**LOW VOLTAGE CIRCUIT BREAKER
SALES & SERVICES**

NO. YAMA525

Indication changes of ACB (For overseas sales companies)

AE-SW: Power supply module of electronic trip relay

2. Content of the change

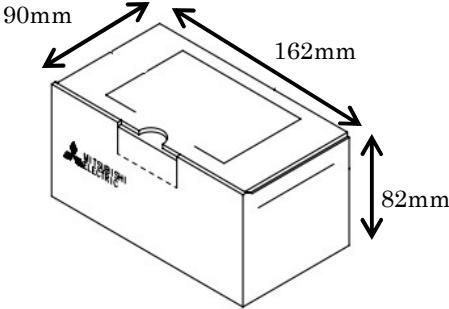
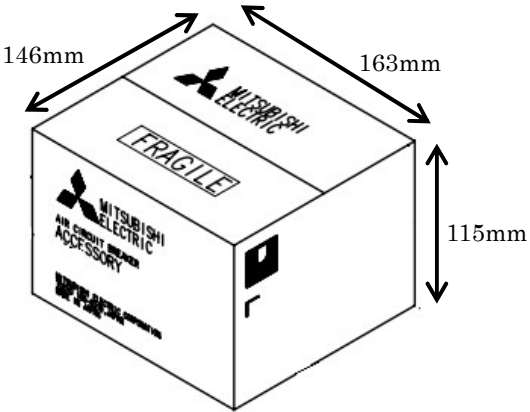
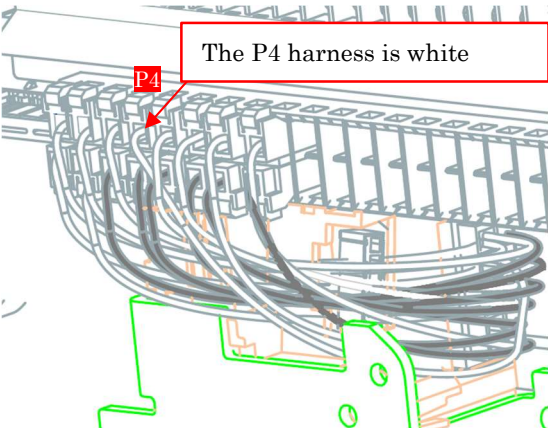
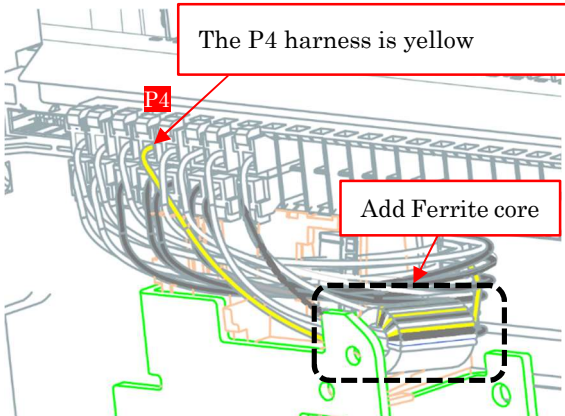
Before the change	After the change
Mounting specification	 <p>[Top]</p>  <p>[Side]</p>	 <p>[Side]</p> 
Power supply Harness

Before the change	After the change
Packing box		
Included parts	 <p>Power supply module</p>	<p>Add Power supply harness with ferrite core</p>  <p>Power supply module</p>
Assemble parts	 <p>The P4 harness is white</p>	 <p>The P4 harness is yellow</p> <p>Add Ferrite core</p>

Specification changes due to discontinuation of the internal parts.
